Environmental Services Site visit notes

Site visit 28 September 2023

Proposed road upgrade - Honeyeater Glade Chidlow

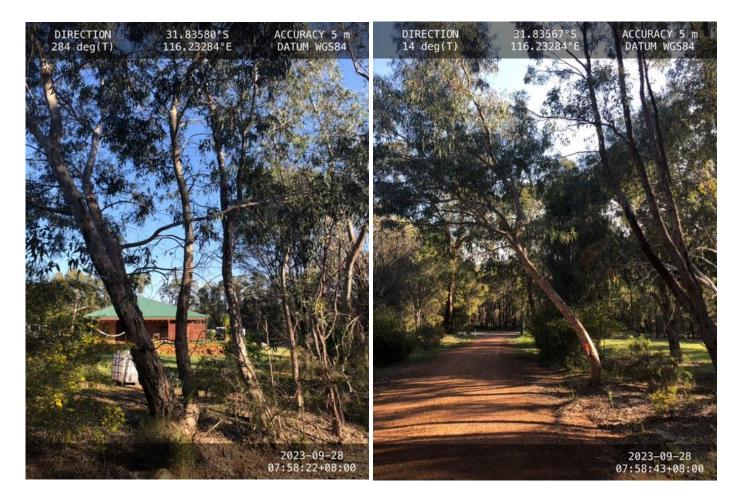
Recommend that removal of vegetation is done with a forestry mulcher. This will minimises ground disturbance and retain the native seed bank. Post construction is it also recommended to reinstate the verge with revegetation of low lying native species.
